**ADDENDUM NUMBER 2**  
ISSUED August 2, 2019

**BLAND COUNTY**  
**ROCKY GAP GREENWAY PROJECT - PHOENIX BRIDGE**

Prepared by: CHA Consulting, Inc.  
1341 Research Center Drive, Suite 2100  
Blacksburg, VA 24060  
CHA Project Number: 30509

EROSION AND  
 SEDIMENT  
 CONTROL PLAN

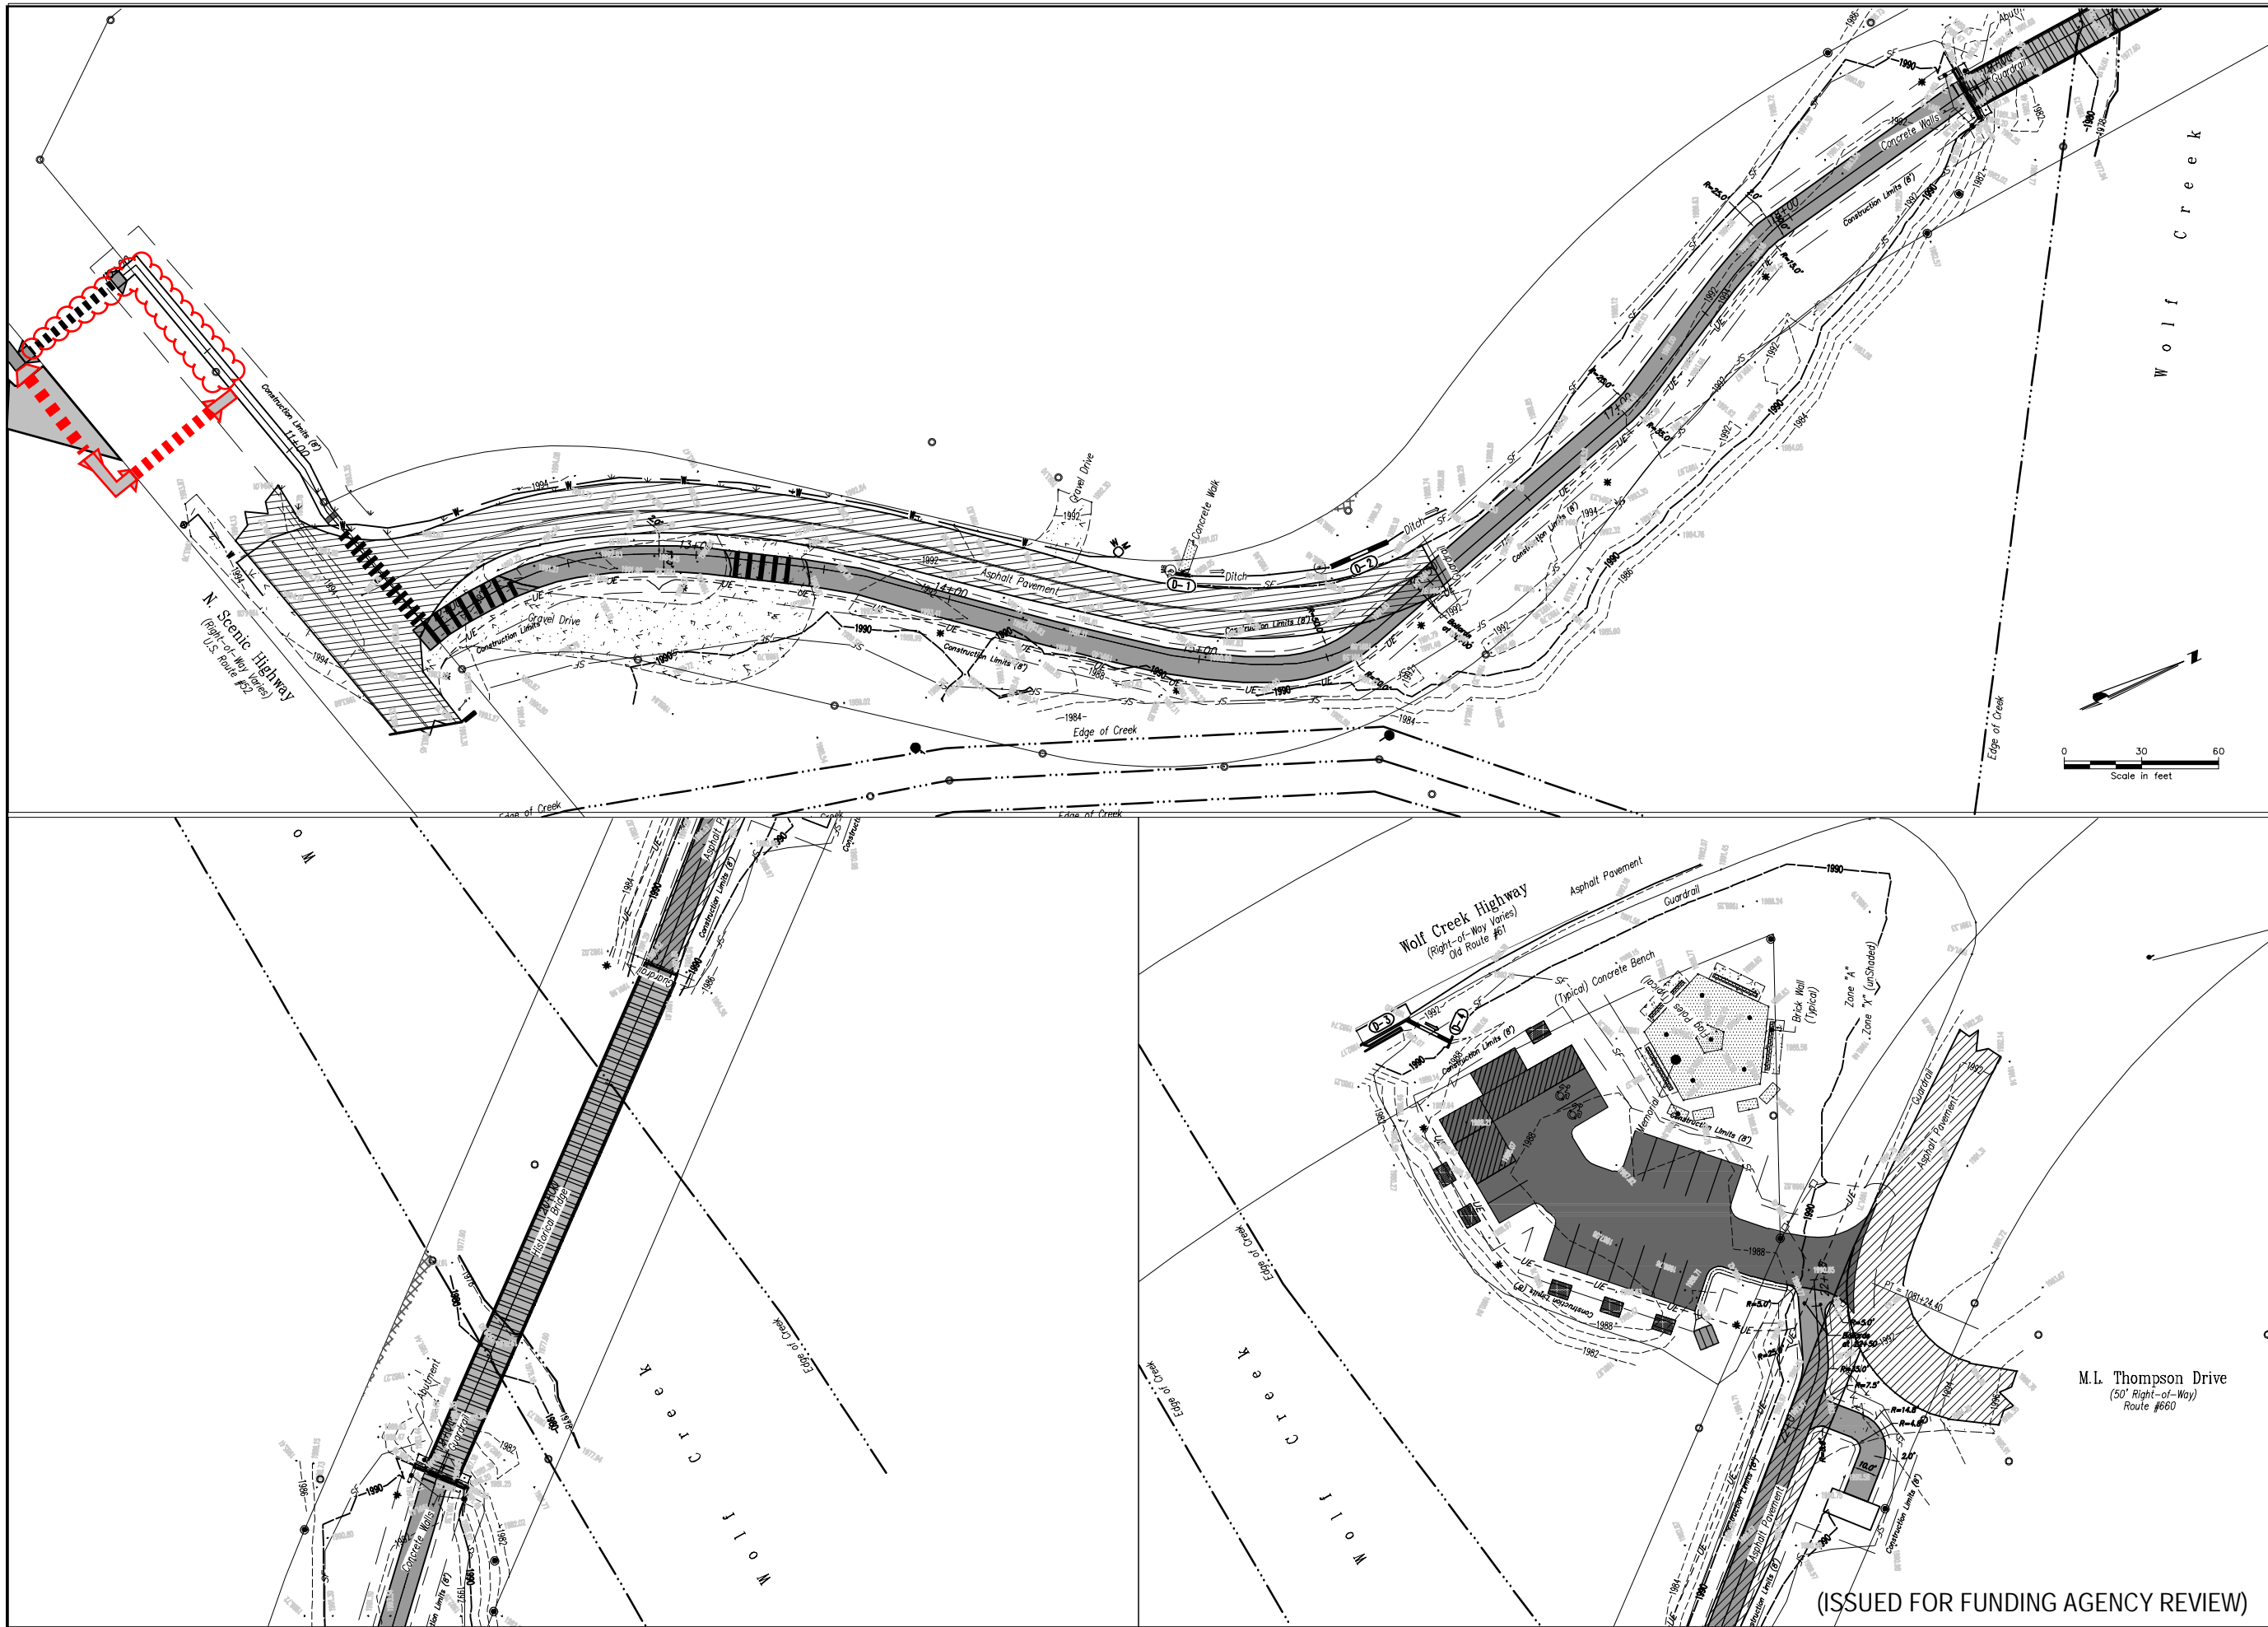
- Ad2-5 Sheet C-300 has been **REVISED** to reflect the new alignment of the sidewalk and crosswalks at the Route 52 intersection. See *attached* revised plan sheet.
